Knocking Noise From Fuel Tank Area

Service Category Engine/Hybrid System

Section Fuel System

YEAR(S)	MODEL(S)	ADDITIONAL INFORMATION
2017 - 2019	Highlander

Figure 1. Without Pulsation Damper Valve Assembly Installed

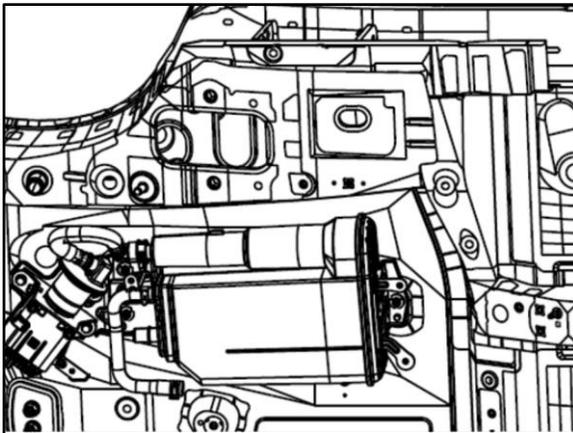
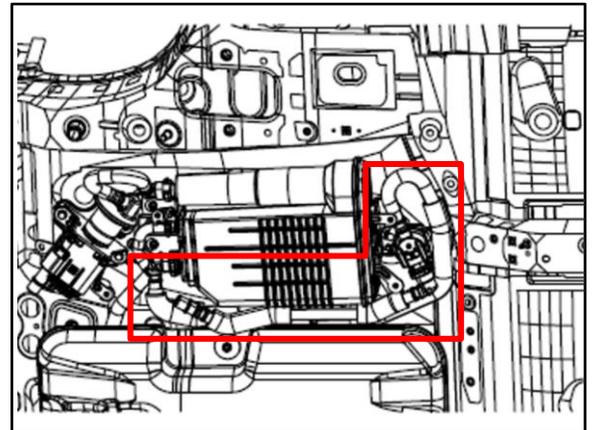
The NEW part can be identified by the addition of a bracket and valve assembly attached to the charcoal canister.

Figure 3.

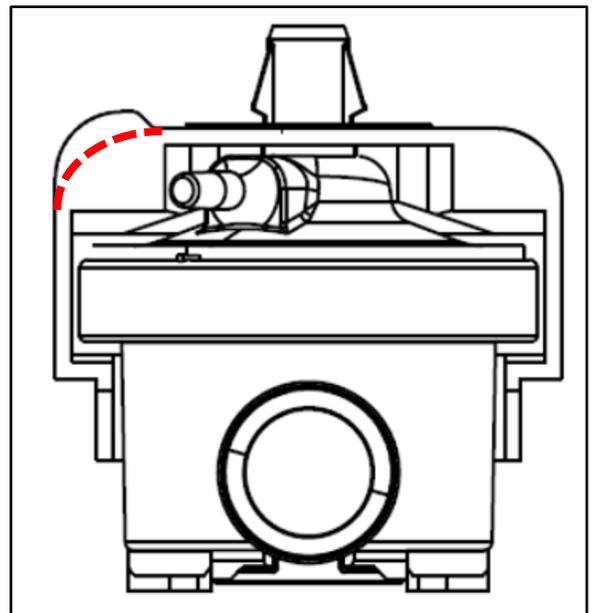
- 2017 – 2019 Highlander:
Engine/Hybrid System – Emission Control – [“2GR-FKS Emission Control: Canister: Removal”](#)
 - D. To provide adequate clearance to the NEW bracket, trim the NEW pulsation damper valve as shown.

E. Ensure clearance between the valve and bracket BEFORE proceeding to the next step.

Figure 4.

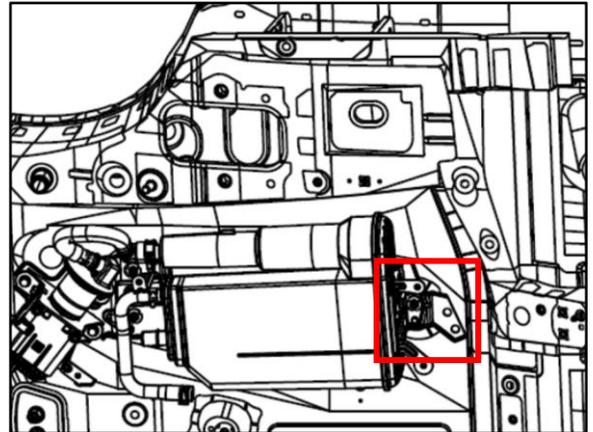
F. Install the NEW bracket to the charcoal canister.

- (1) Remove the nut from the front of the charcoal canister.
- (2) Install the bracket on the stud.
- (3) Tighten the nut and valve assembly plate into place.

Torque: 5.5 N*m (56 kgf*cm, 49 in*lbf)

Figure 5.

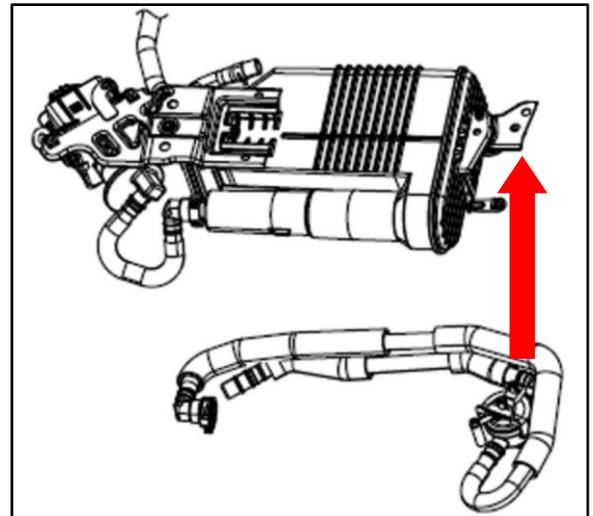
G. Install the NEW pulsation damper valve assembly onto the NEW bracket.

Push both retaining clips of valve assembly through the two holes on the bracket.

Figure 6.

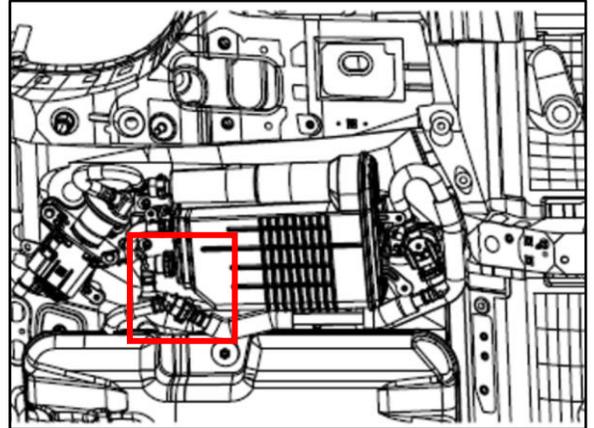
- H. Connect the NEW pulsation damper valve assembly to the charcoal canister.

Figure 7.

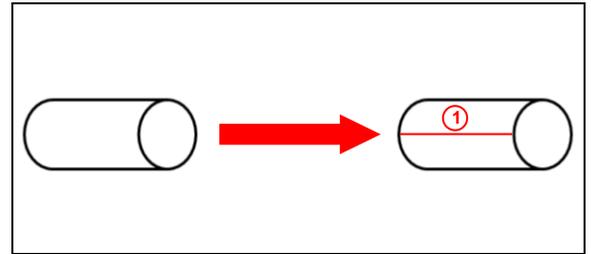
- I. Cut the two reflect sleeves as shown.

Figure 8.

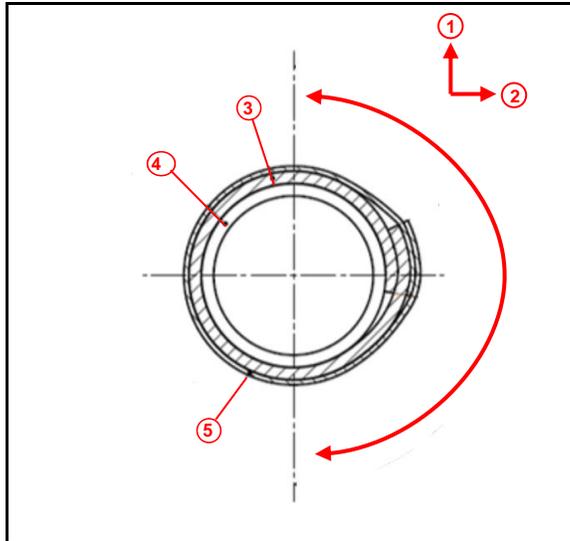
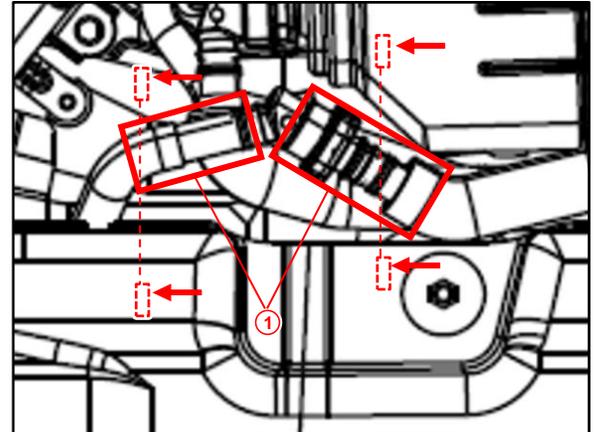
- J. Wrap the two reflect sleeves around each of the vent tube connections and tape them into place as shown in Figures 8 and 9.

Figure 10. Zip-Tie Locations

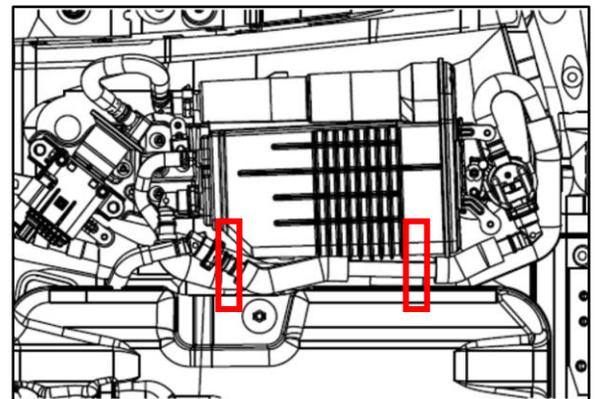
- K. Using the zip ties supplied, tie the NEW pulsation damper valve assembly to the purge line as shown by doubling the zip ties together for each location.

Double or connect the zip ties to provide adequate length to secure assembly.

- L. Trim the excess zip-tie tail between 3 mm – 5 mm.
